**REPORT
INDEPENDENT HYDROLOGIST REVIEW
ALTAROCK ENERGY
EGS DEMONSTRATION PROJECT
NEWBERRY, OREGON**

February 24, 2011
Project No. 116075

**Subject: Independent Hydrologist Review Report
AltaRock Energy
EGS Demonstration Project
Newberry, Oregon**

PROJECT AREA MAP	
INDEPENDENT HYDROLOGIST REVIEW EGS DEMONSTRATION PROJECT NEWBERRY, OREGON

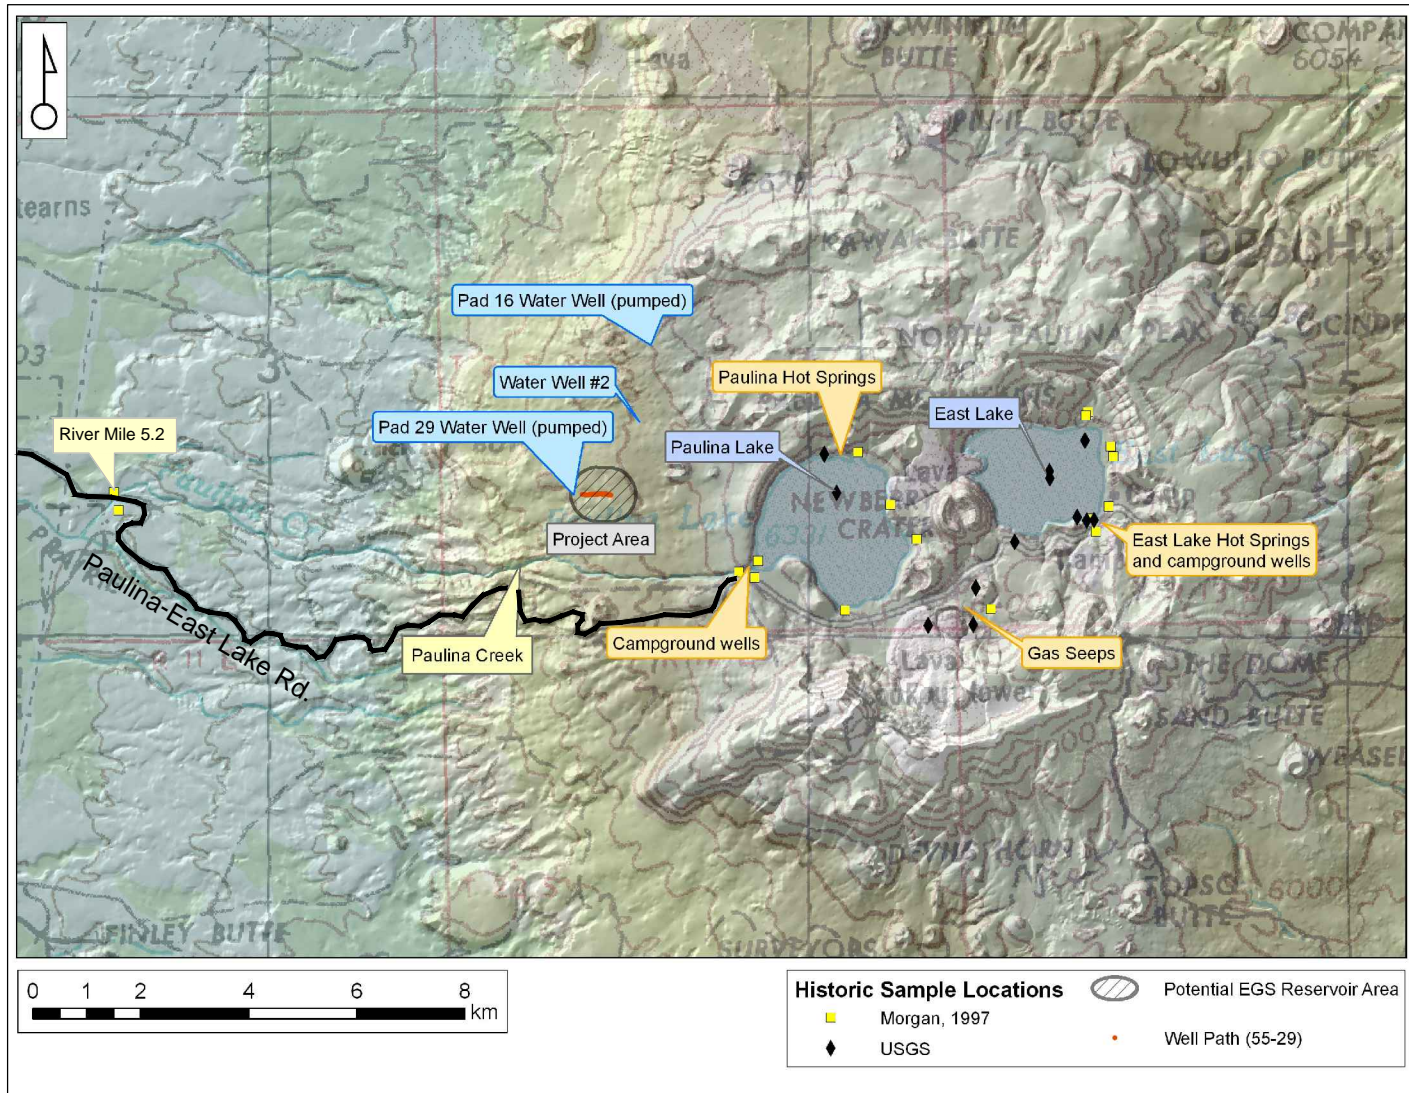
above the Paulina-East Lake Road crossing at RM 5.2 (Figure 1), the stream loses approximately 0.75 cfs/mile to groundwater (Morgan and others, 1997). Current aquifer testing in the project vicinity (Schwartz and others, 2010) indicates a relatively low transmissivity aquifer which would indicate a relative steep cone of depression around the water supply well and a small (less than 2,500 feet) radius of influence (amount of water level drawdown as one moves away from the well). These conditions further imply that the pumping of the water supply well on Pad 29 will not impact flows in Paulina Creek.

Neither of these lakes is in danger of being impacted by the demonstration project. Paulina Lake is over 2 miles from the test Pad 29 location and East Lake is even farther away. The project site aquifer being used for water supply for the test is separated from the caldera lakes aquifer by geologic structures that impede the lateral and vertical flow of groundwater. The bottom of Paulina Lake is also over 2-miles horizontal distance and over 1-mile vertical distance from the EGS stimulation zone (Figure 1).

Paulina Creek, at the crossing of County Highway 21 (also known as Paulina-East Lake Road and U.S. Forest Service Road 21) at RM 5.2, has been monitored by the US Geological Survey (Morgan and others, 1997) (Figure 1). The hydrologic flow patterns into Paulina Lake and its connection to the project site aquifer have been discussed in several of the responses provided above. We do not believe there is a need for monitoring of water flow/quality downgradient of the site at surface water bodies.

CROSS SECTION LOCATION MAP

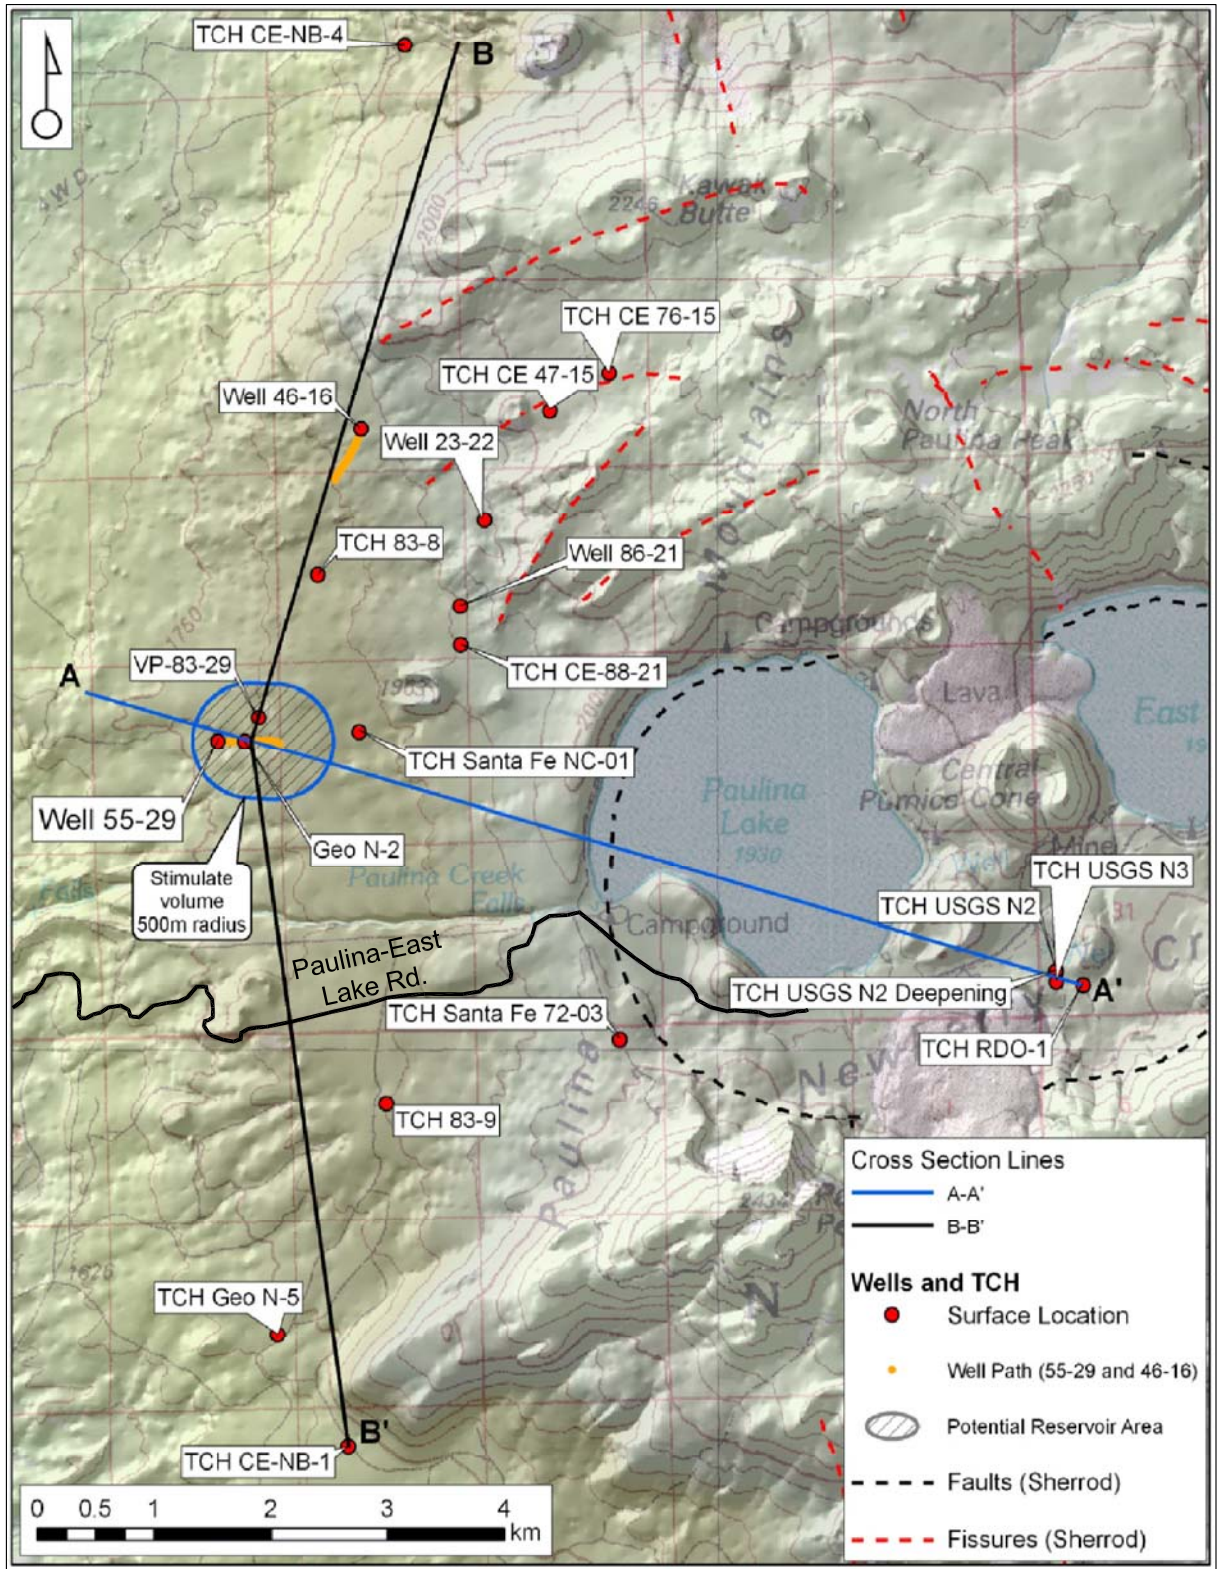
The aquifer within Newberry Caldera is recharged from precipitation and snow melt. Paulina and East Lakes are situated on both a topographic and hydrologic high meaning that water flows from these areas down to surrounding areas including the water supply well on Pad 29. The withdrawal of water from the water supply wells on Pad 29 or Pad 16 cannot affect the flow of water from the lakes since the lakes are hydrologically upgradient of these wells (Figures 2, 3, and 4).

2010) provides a summary of the hydrogeologic environment at the proposed test site (Figures 2, 3, and 4). This document along with several others we reviewed (see References section) show the base of the regional aquifer system is approximately 5,000 feet above the top of the proposed EGS reservoir zone. The estimated EGS reservoir created through hydraulic stimulation at the Pad 29 site will be a network of fractures extending approximately 1,500 feet radially. Even if these fractures extended upward from the top of the EGS reservoir zone, it would still be several thousand feet below the bottom of the project site aquifer. Given the very low permeability of the receptor rock throughout the length of the vertical borehole below the project site aquifer, it is unlikely that fluids would be able to migrate vertically during the testing period.

CROSS SECTION A-A'	
INDEPENDENT HYDROLOGIST REVIEW EGS DEMONSTRATION PROJECT NEWBERRY, OREGON

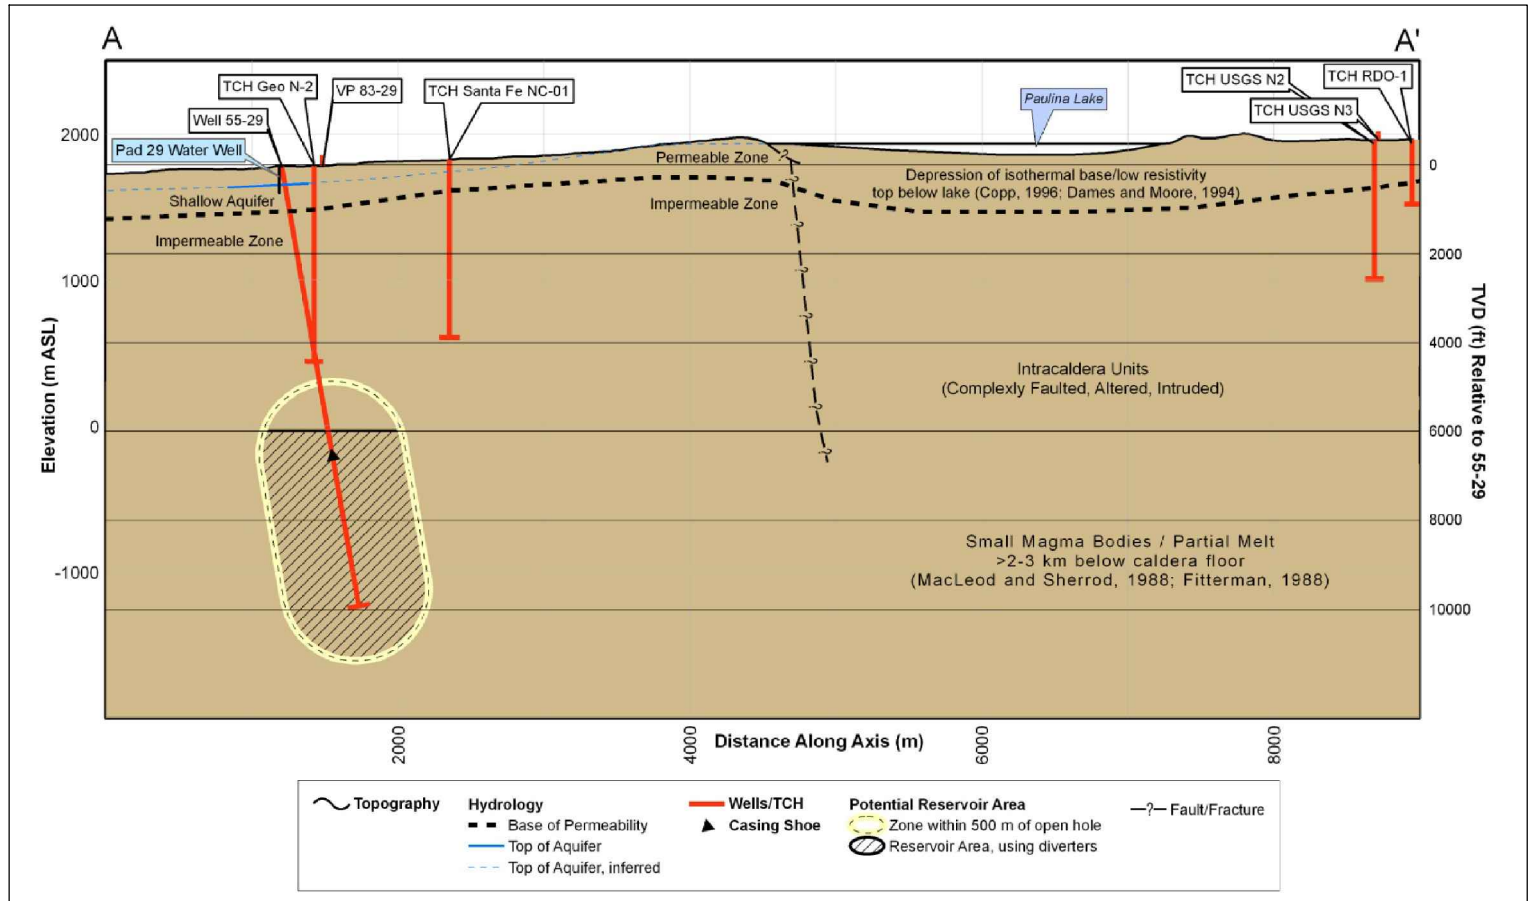
The estimated horizontal distance from the water supply well at Pad 29 to Paulina Creek is 4,790 feet or just less than 1 mile. The conceptual hydrogeologic model for the shallow aquifer (Figures 2 and 4) indicates that Paulina Creek is in direct connection
